HISTORIC PRESERVATION COMMISSION

STAFF REPORT Department of Growth Management

MEETING DATE:	June 1, 2016
PROJECT:	Lot 18, 34 Tabby Shell Rd. – New Construction: Single-Family Residential
APPLICANT:	Sean Lewis
PROJECT MANAGER:	Erin Schumacher, Senior Planner

PLAN REVIEW COMMENTS FOR COFA-04-16-009606

FRONT & RIGHT ELEVATIONS

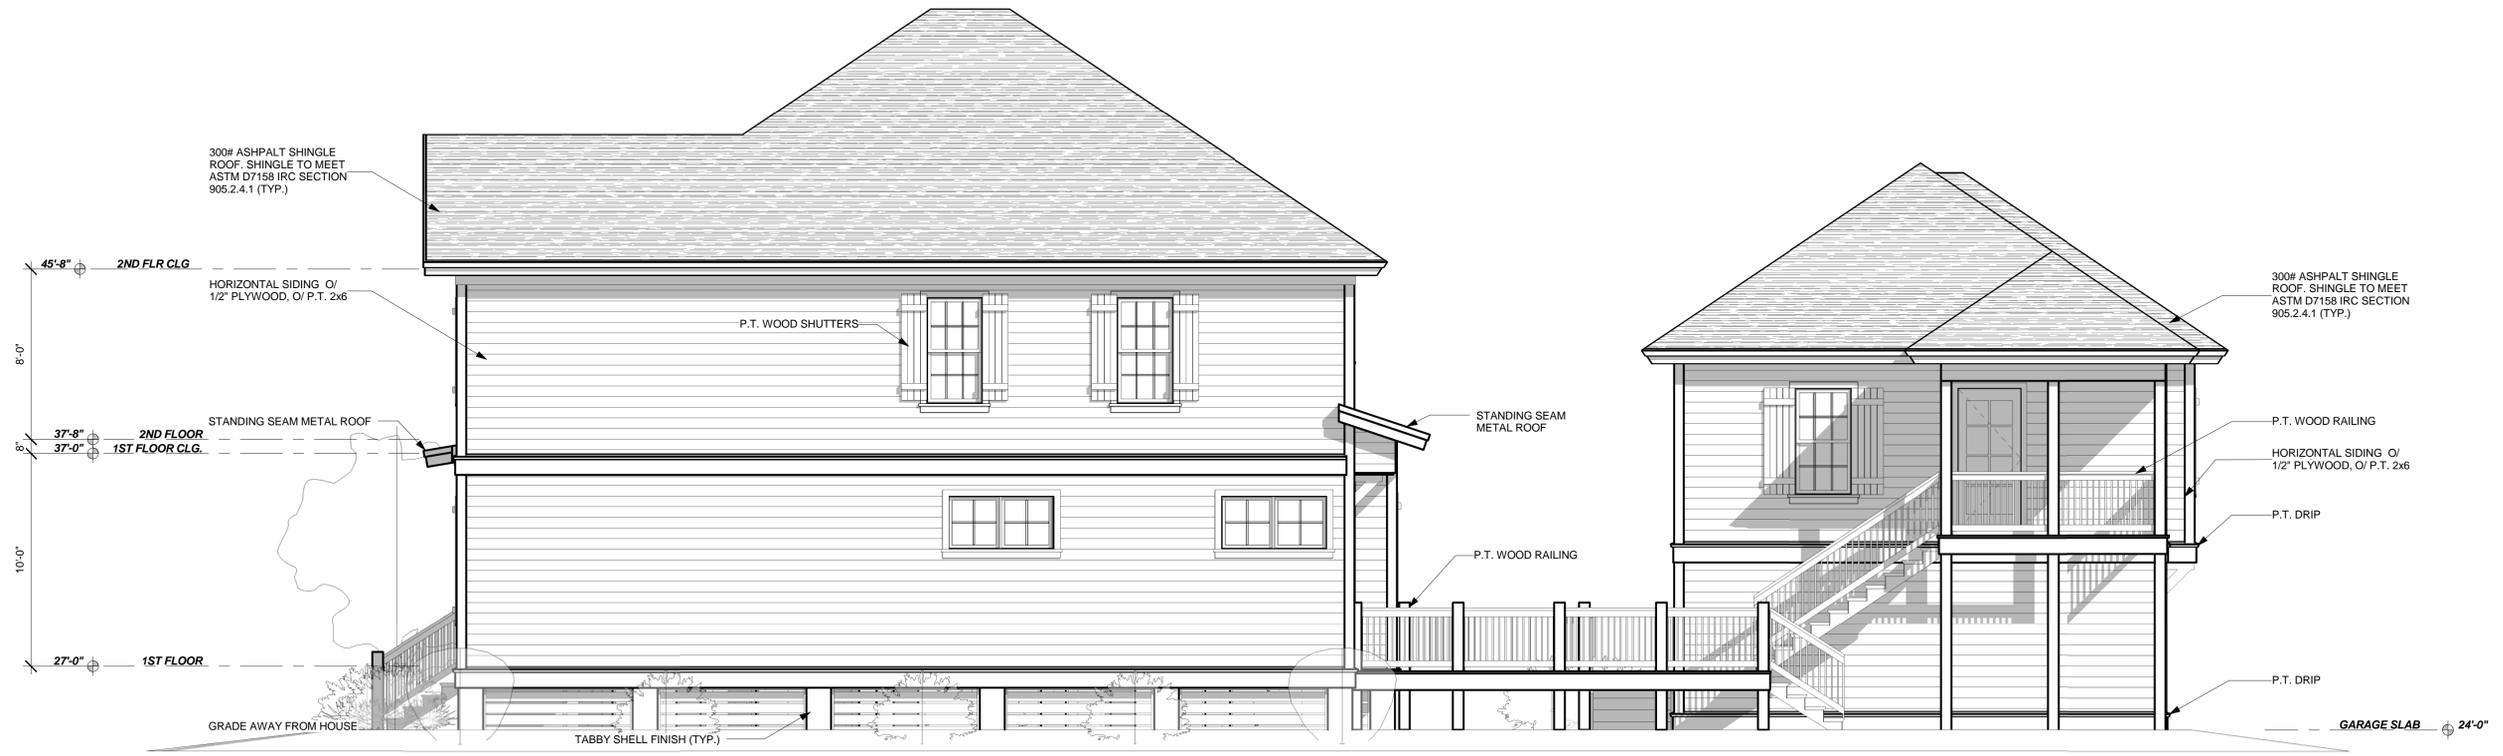
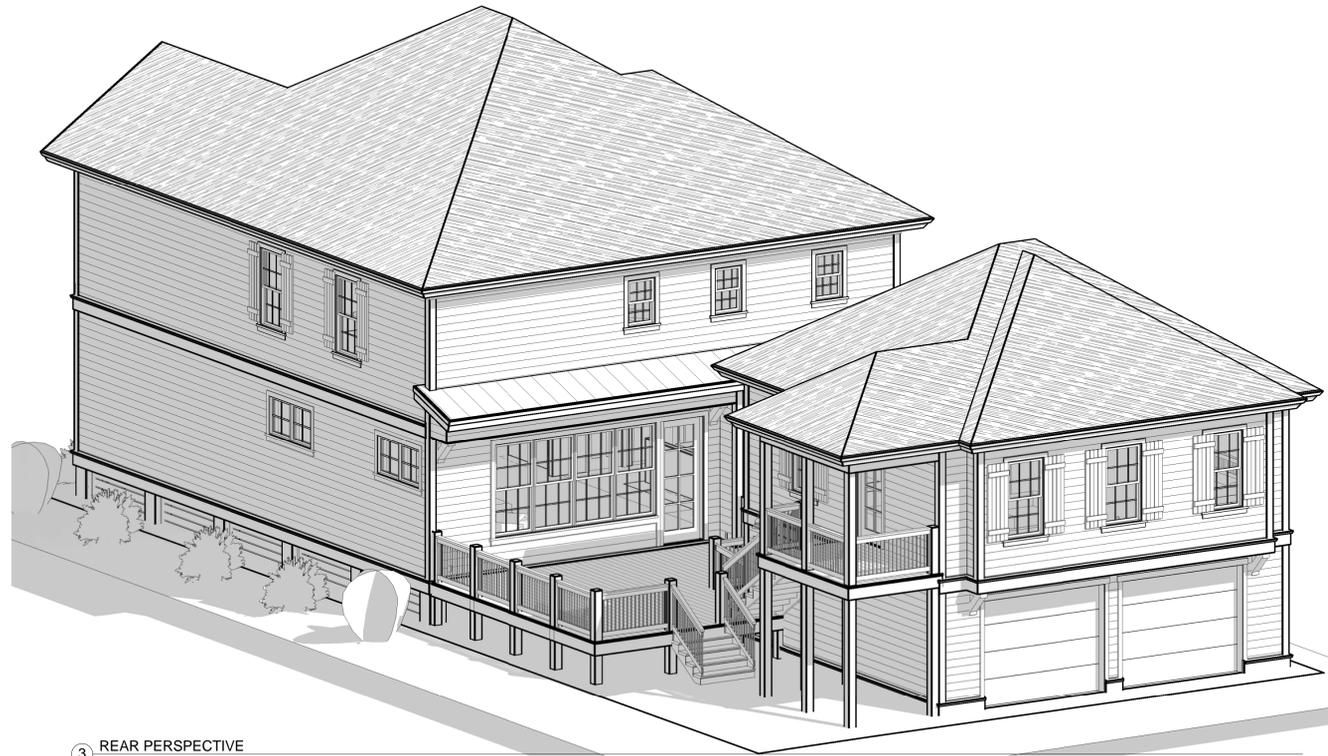
1. On the right side elevation the pair of transom windows flanking the fireplace, are horizontal, rather than vertical in nature. Per the UDO, windows may be rectangular or square and must be vertically oriented. Revise windows to a permitted configuration. (UDO Section 5.15.6.I.1.b. and Section 5.15.6.I.3.a)

REAR & LEFT ELEVATIONS

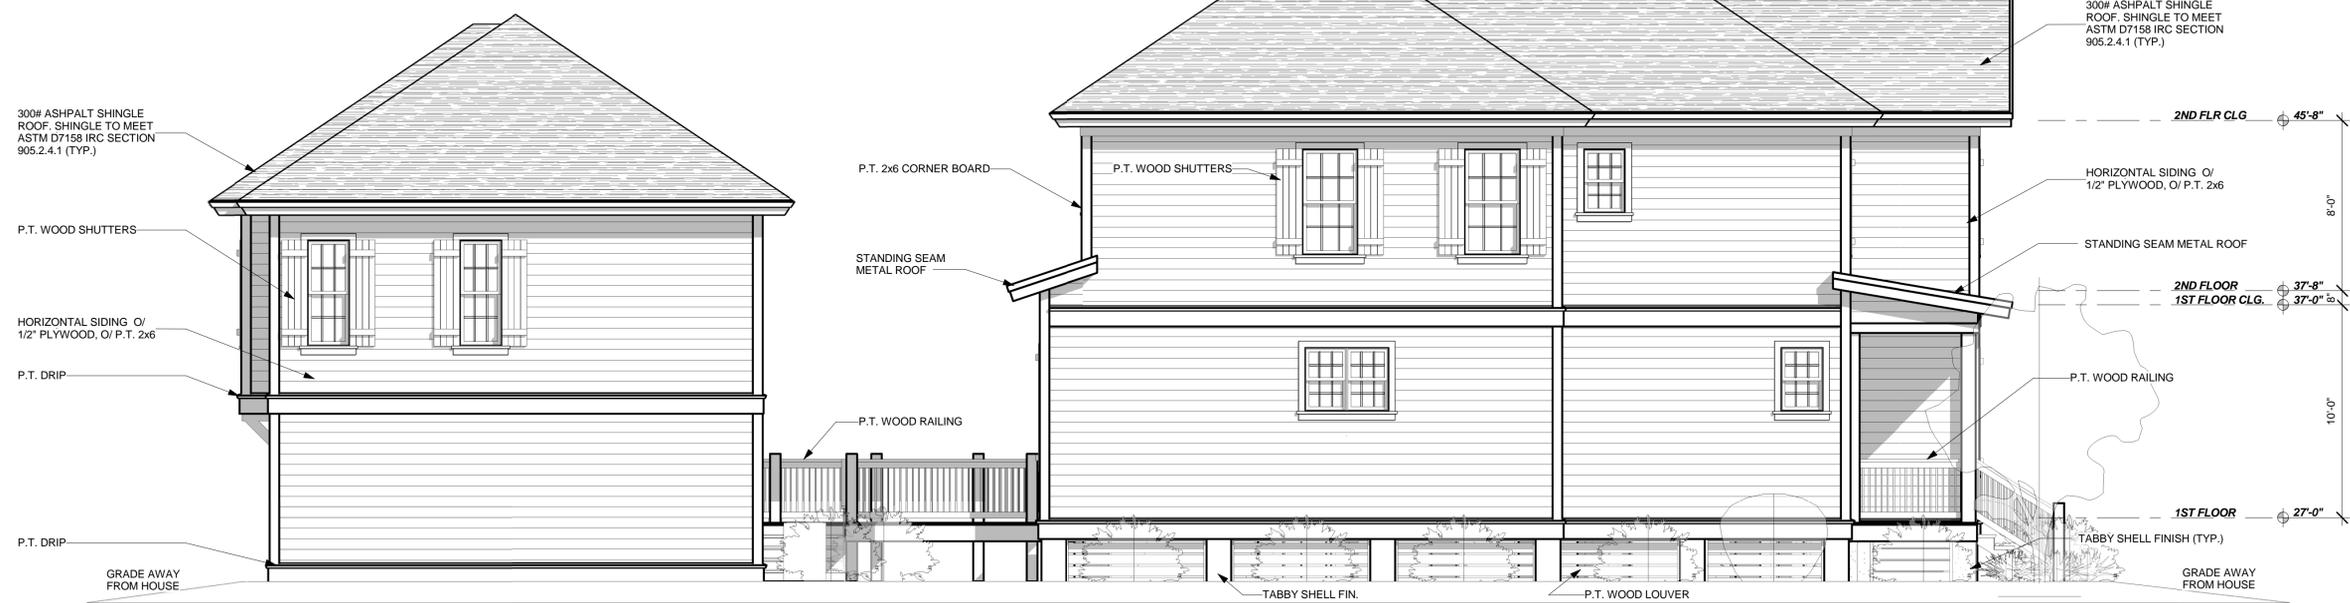
5. Rooflines shall be simple and correspond to the major massing of the building; roof forms that overwhelm the mass of the primary building form and complicated rooflines are to be avoided. As such, the gable roof on the rear elevations at the garage, seems out of place. Considers making it a hip roof. It exposes a large amount of siding, in the gable condition and is lacking in detail. (UDO Section 5.15.5.F.2.b.)

WALL SECTION & DETAILS

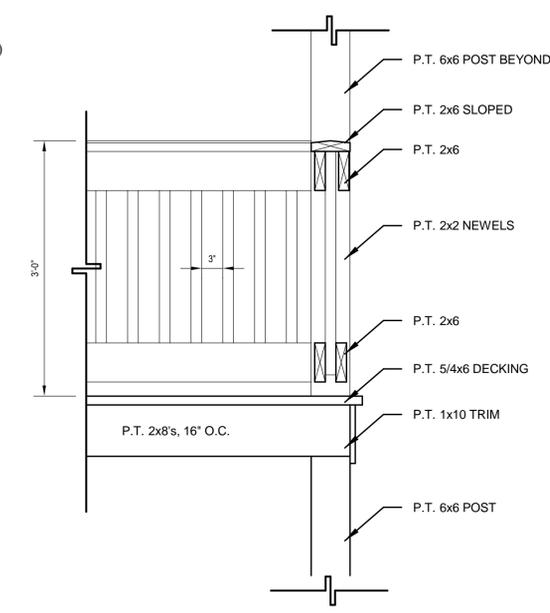
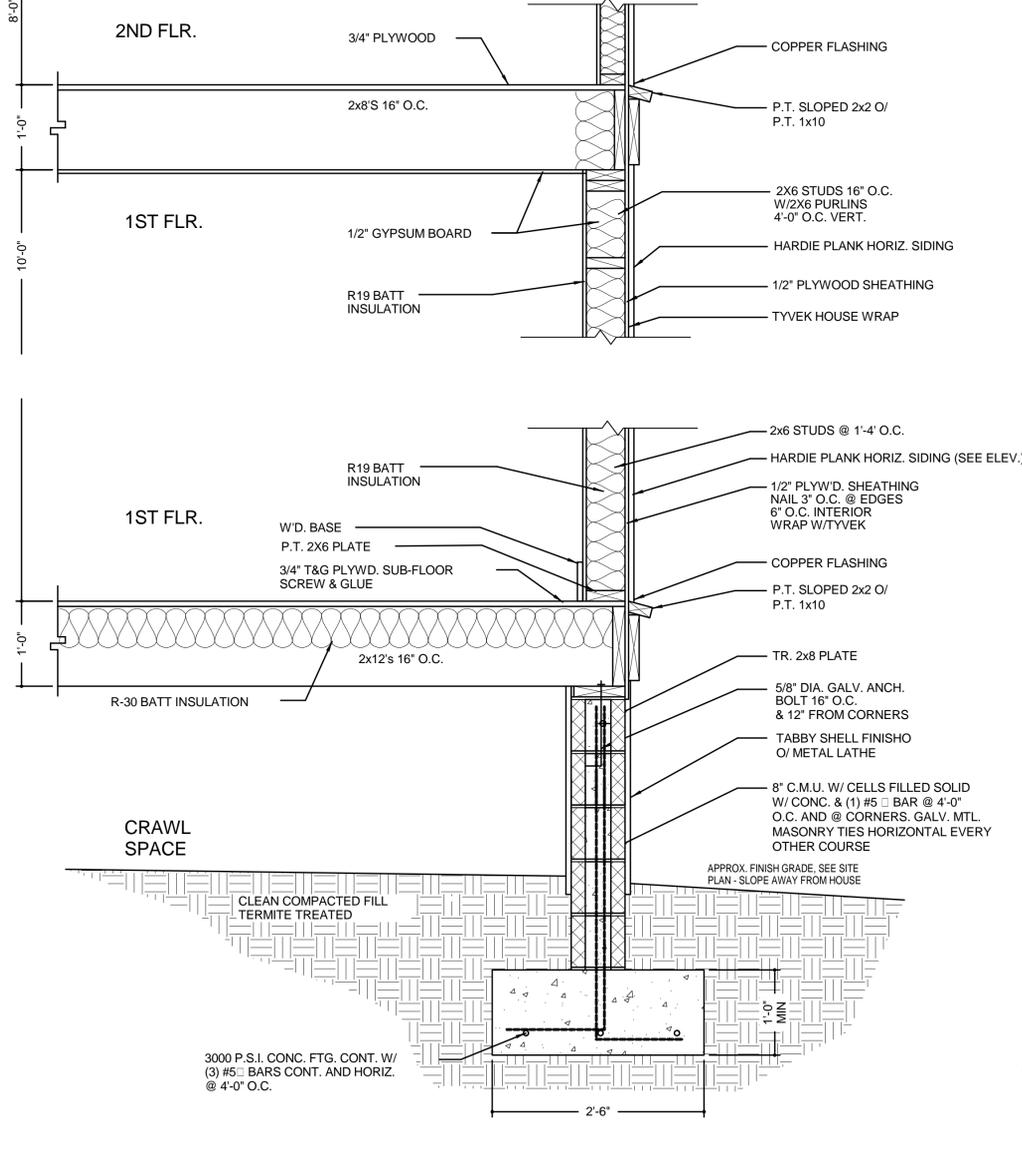
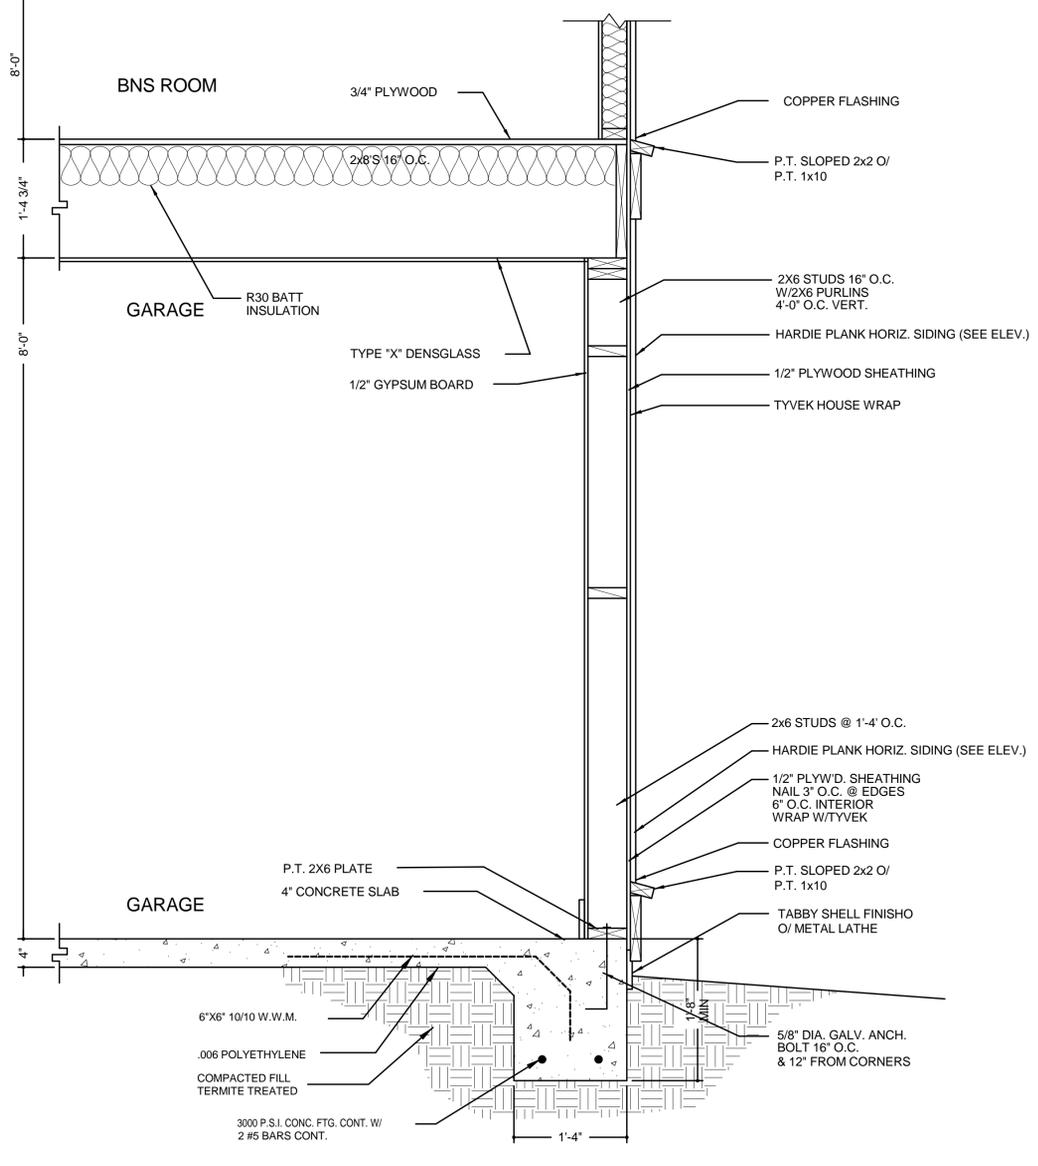
- 1) Section 5.15.6.7.a. Corners and Water Tables Corners. The UDO notes that water table should be 2x stock with a bevel. The proposed plans note the use of 1x10 as the skirt board. As this is considered part of the water table trim, it must be revised to a 2x material to meet the requirements of the UDO.

1. Per Section 5.15.6.7.a. of the UDO, the water table trim material must be revised to a 2x material.
2. Per Section 3.22.2 of the UDO, a Town of Bluffton tree removal permit is required for any trees over 14 inches DBH proposed for removal.
3. Per the Applications Manual, a final approval letter from the Tabby Roads HARB shall be provided to Town Staff stating that the plans have been reviewed and approved.
4. Per Section 5.15.6.a. and 5.15.5.F.4.c. Consider adding shutters to all windows that will accept them for better consistency and a more traditional application.
